भारत सरकार
Government of India
विद्युत मंत्रालय
Ministry of Power
उत्तर क्षेत्रीय विद्युत समिति
Northern Regional Power Committee

Subject: Minutes for 65th Protection Sub-Committee Meeting-reg

**Minutes of
65th Meeting of Protection Sub-Committee (PSC) of
Northern Regional Power Committee**

Date and time of meeting : 30.12.2025 11.00 Hrs.

DR of bus bar relay at Kota Sakatpura(RS)

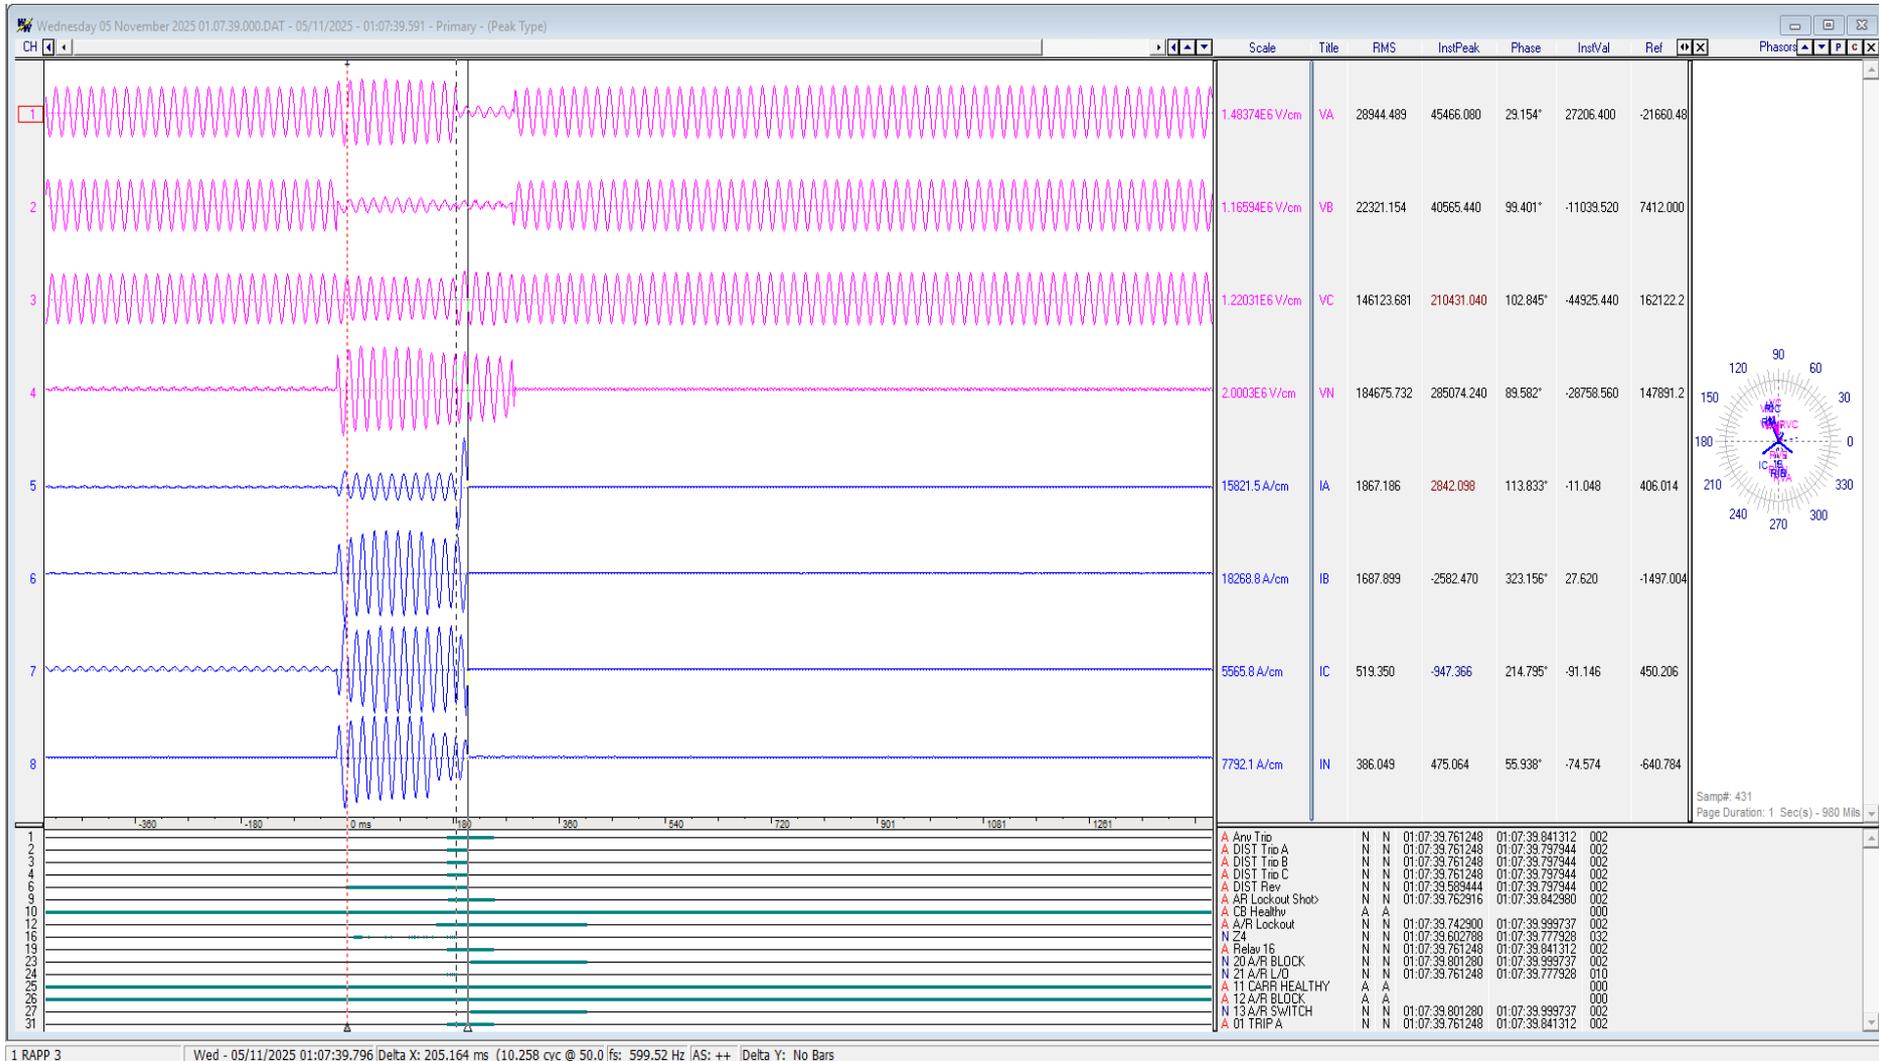
- Y-N fault converted into R-Y fault
- Bus bar protection operated with delay of ~220msec
- Time not synced

3.5 DR from PU of 220 kV Bus Coupler

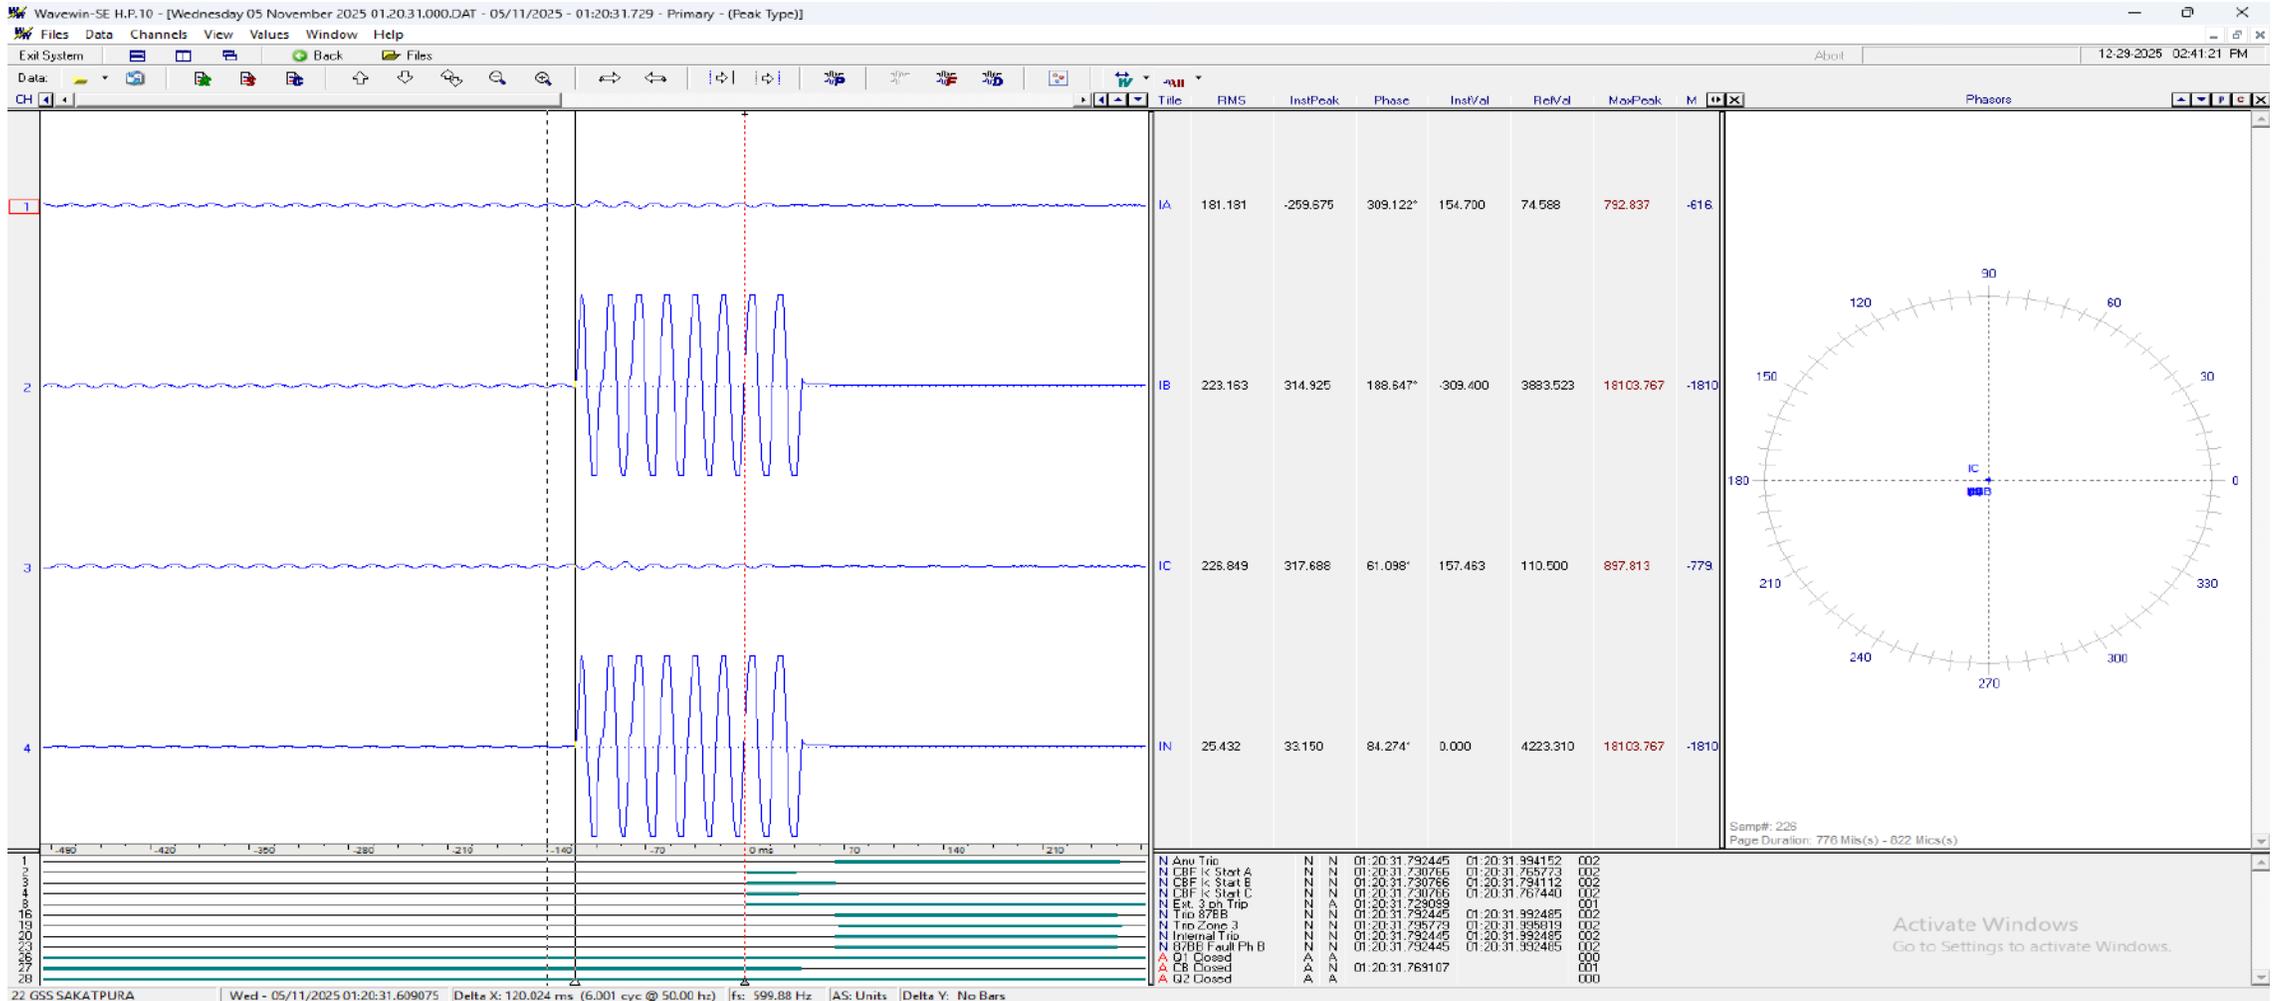
- **01:20:31.610** – Fault initiation with current spike in Y-phase.
- **01:20:31.729** – External three-phase trip signal became high, indicating operation of electromechanical earth fault protection with **40% plug setting** and **TMS = 0.05**.

3.8 DR of Distance Relay of 220 kV RAPP-A line 2

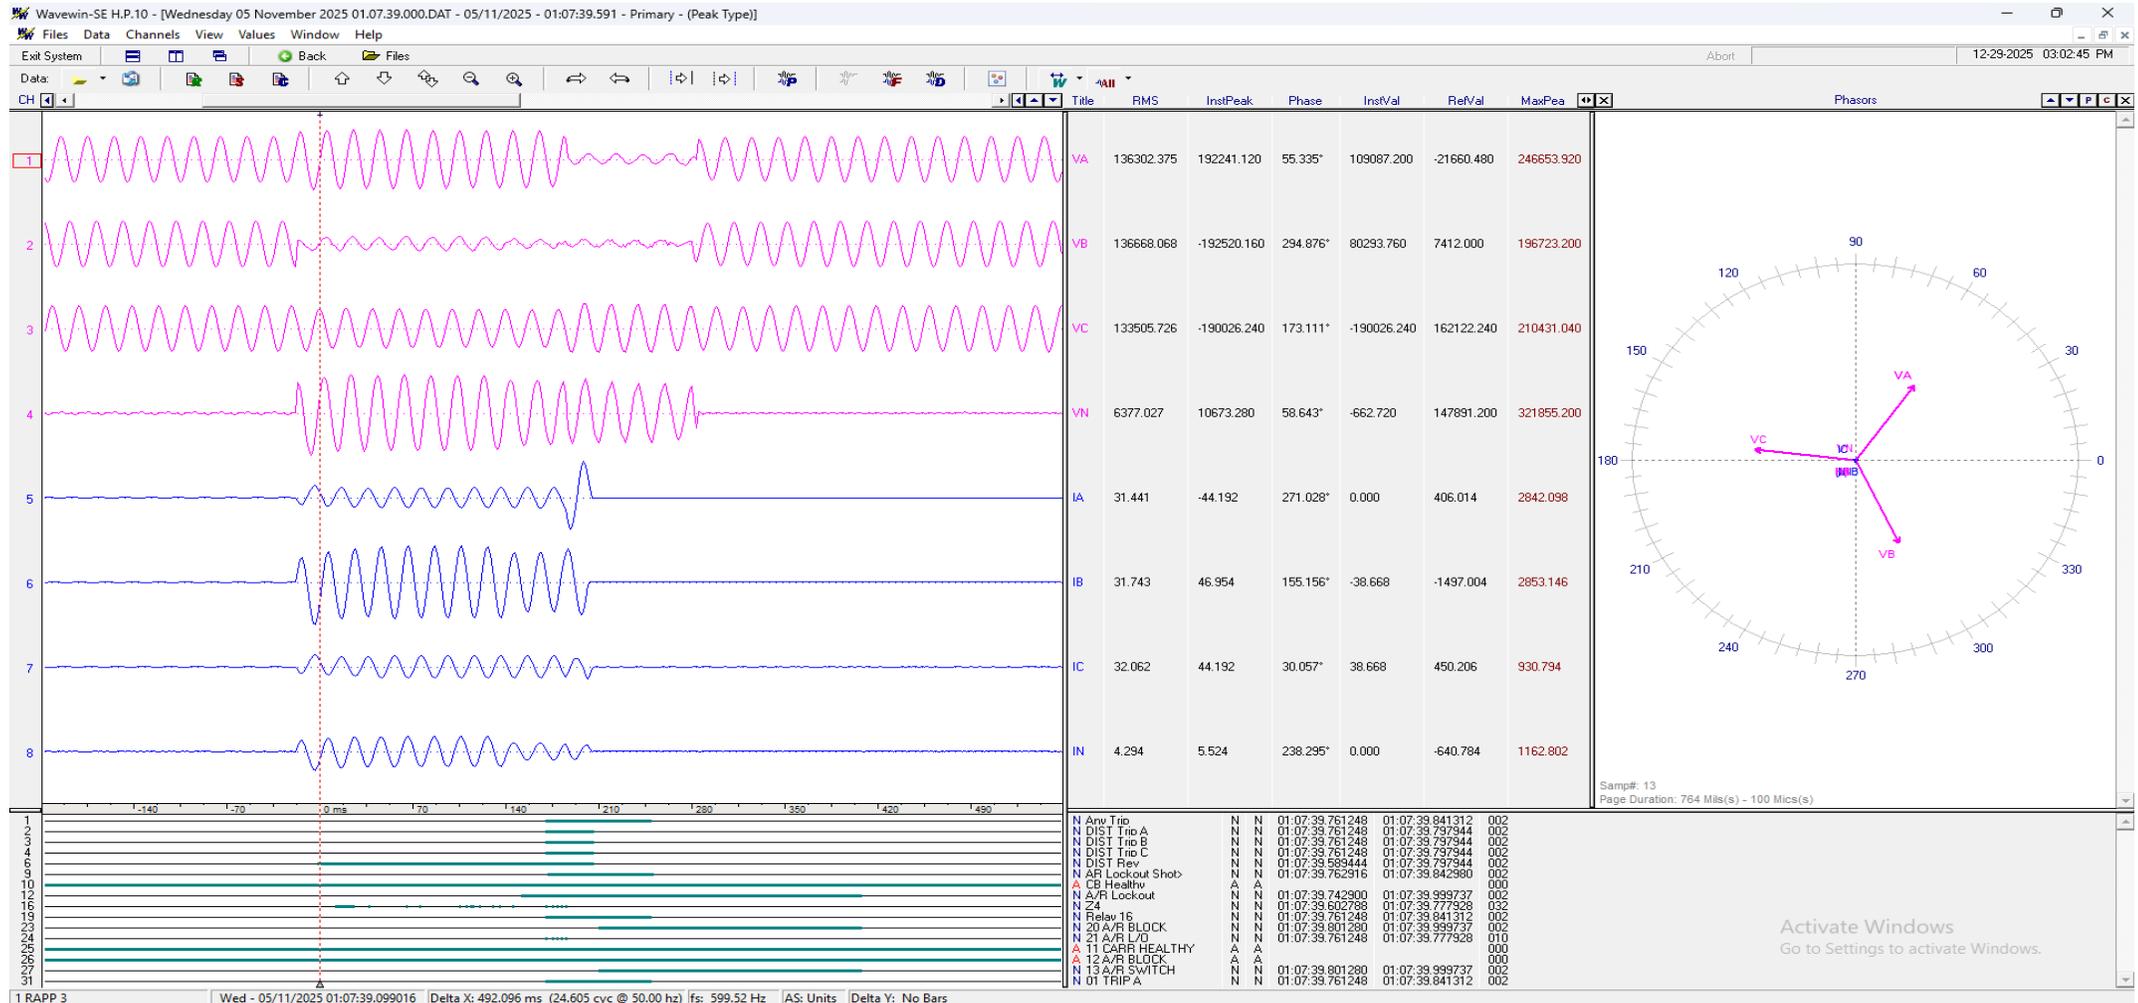
- The feeder was connected on **220 kV Main Bus-B**.
- Only the **Main-II distance relay (make MiCOM)** operated and tripped in **reverse Zone-4**.
- **Main-I distance relay** did not operate.

DR of 400 KV Kishenpur(end)-Moga (PG) Ckt-2

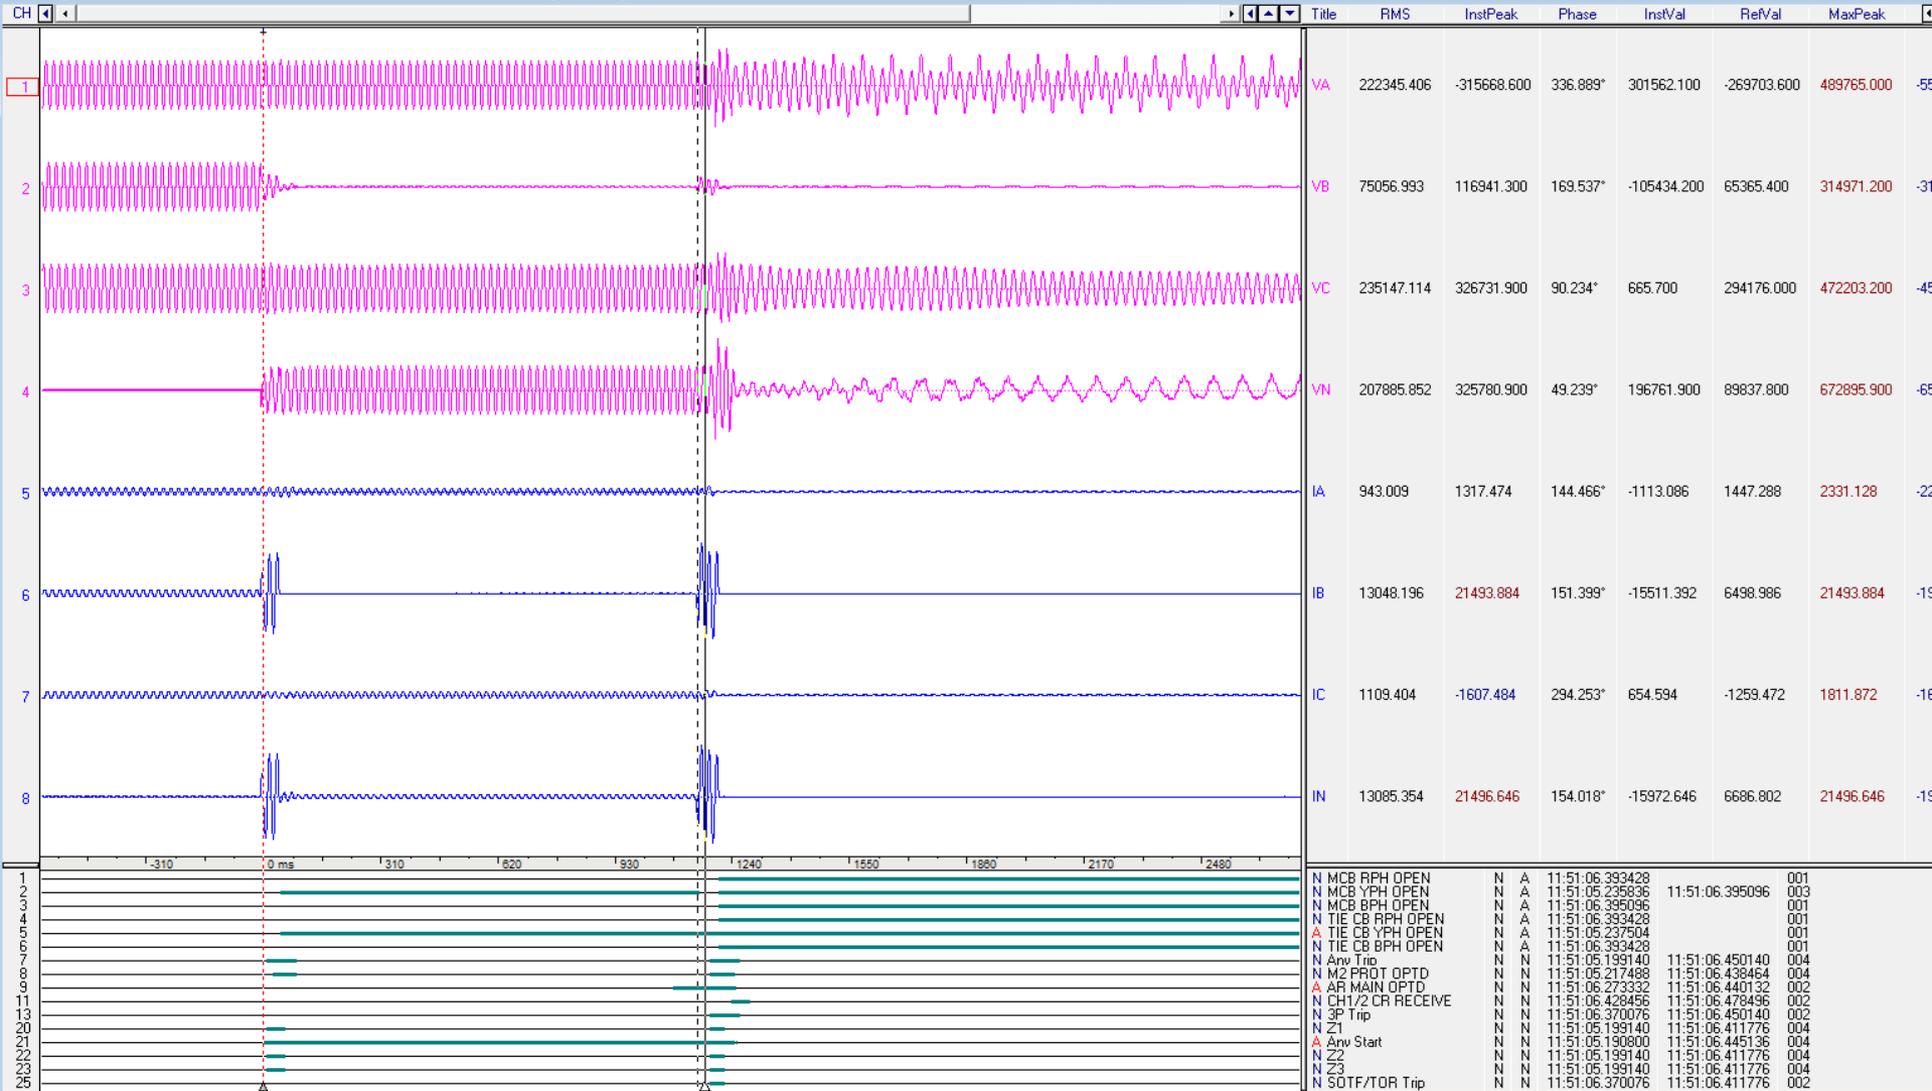
- ✓ Y-N fault (unsuccessful A/R=> permanent fault); $I_y \approx 13.41\text{kA}$
- ✓ Fault sensed in zone-1 at Kishenpur end; Main-II relay operated.

DR of 220 KV Samba(PG) (end)-Chowadhi(JK) (PDD JK) Ckt

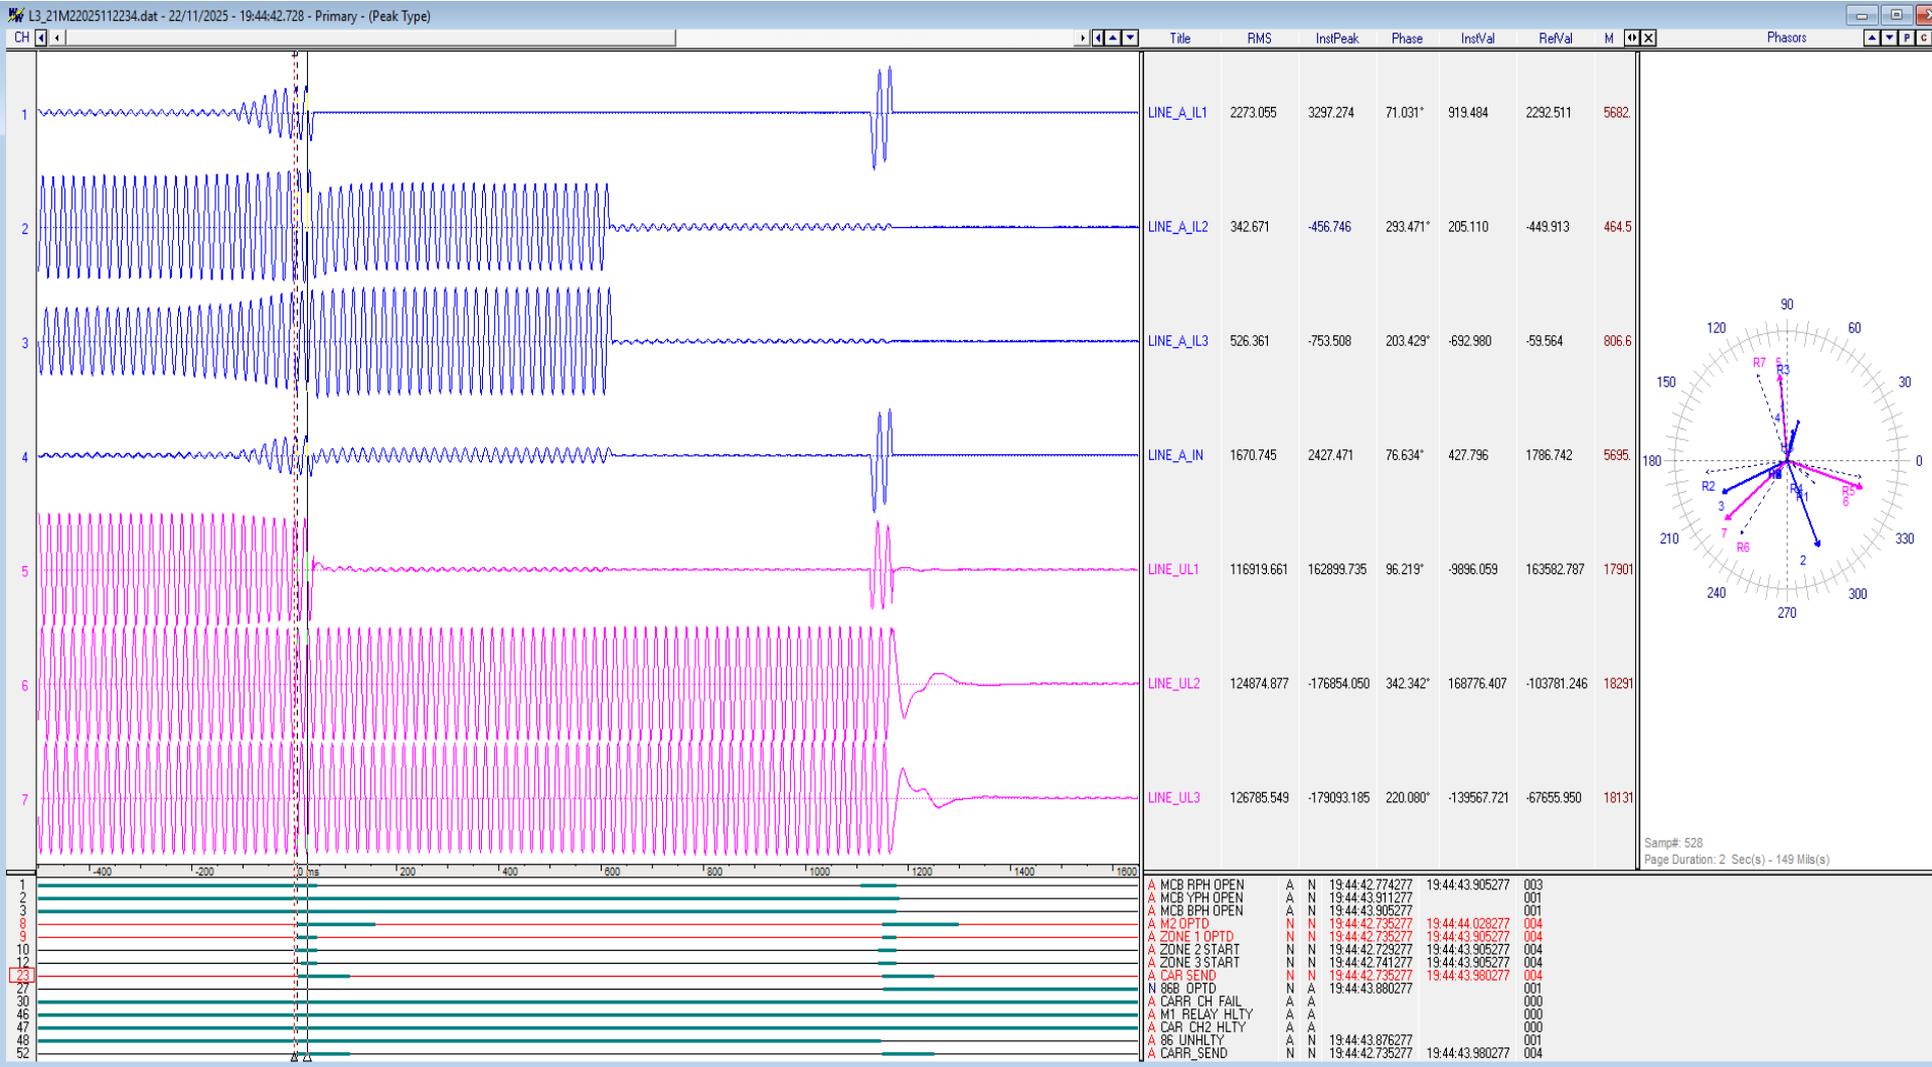
- ✓ R-N fault; Fault current: $I_r \approx 2.273\text{kA}$ and 4.134kA (during A/R)
- ✓ Zone-1 distance protection operated at Samba end (Main-II).
- ✓ Carrier sent from Samba, but not received at Chowadhi.
